THE MARYLAND-NATIONAL CAPITAL PARK AND PLANNING COMMISSION

Site Plan Review

Triangle Park

8-01014

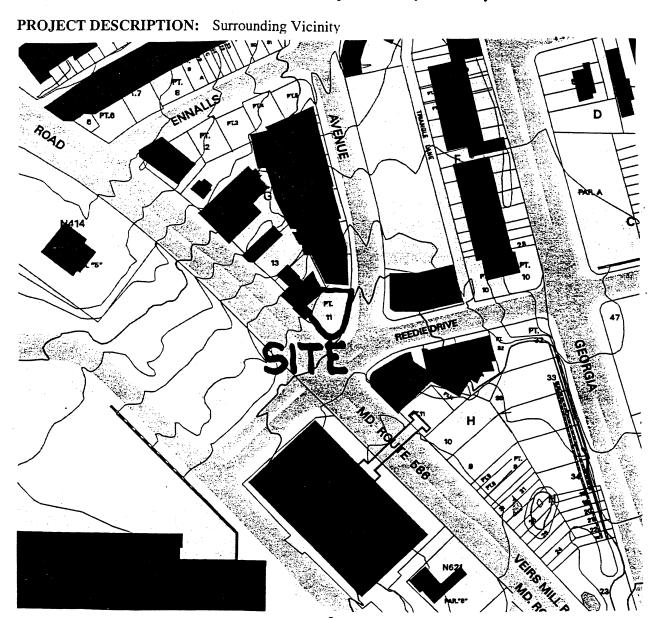
- 2. Paving of the public open space between the building and the existing sidewalk with the approved Wheaton Streetscape paver as specified in the Wheaton CBD Road Code Design Standards. dated April 1990, or with stamped concrete in a pattern and color compatible with the standard Wheaton Streetscape paving. The existing sidewalk is to be re-paved later by the County, through the Department of Housing and Community Affairs' program for Wheaton CBD infrastructure improvements. Signature set to provide for coordination of this design with streetscape elements.
- 3. Conditions of letter conditionally approving the Storm Water Management concept, dated December 1, 2000.
- 4. On signature set, revise north driveway wings so as not to overlap property line.
- 5. Designate widened ROW on Veirs Mill and truncation at corner with Grandview for future dedication on Signature Set.

- 6. Setback from building to the north (and therefore proposed footprint) subject to code interpretation at time of building permit by MCDPS.
- 7. Show existing parking spaces/meters and adjacent driveways on Signature Set.
- 8. Participate in Wheaton CBD Transportation Management Organization when it is established.

PROJECT DESCRIPTION: Site Description

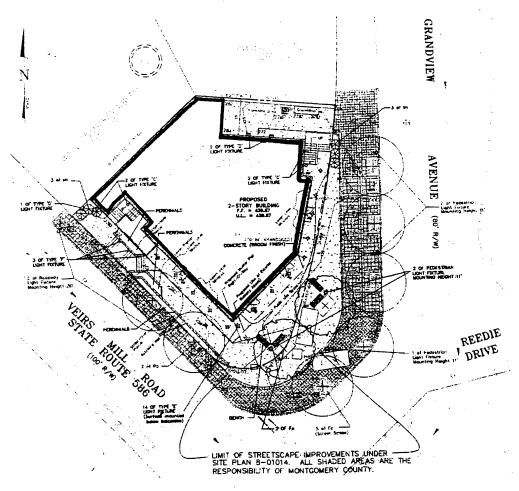
This small, corner site containing 6666 square feet is bounded by three streets and the sides of two small retail buildings. A Little Tavern presently occupies the west corner of the site; it is to be removed. The existing parking lot occupying the remainder slopes gently down from west to east across the site.

The Veirs Mill sidewalk is eight feet wide; the Master Plan contemplates a future widening of ten feet. On Reedie Drive the sidewalk is fifteen feet wide, and on Grandview it is twenty feet. the Veirs Mill curb lane is used for bus stops and curb parking.
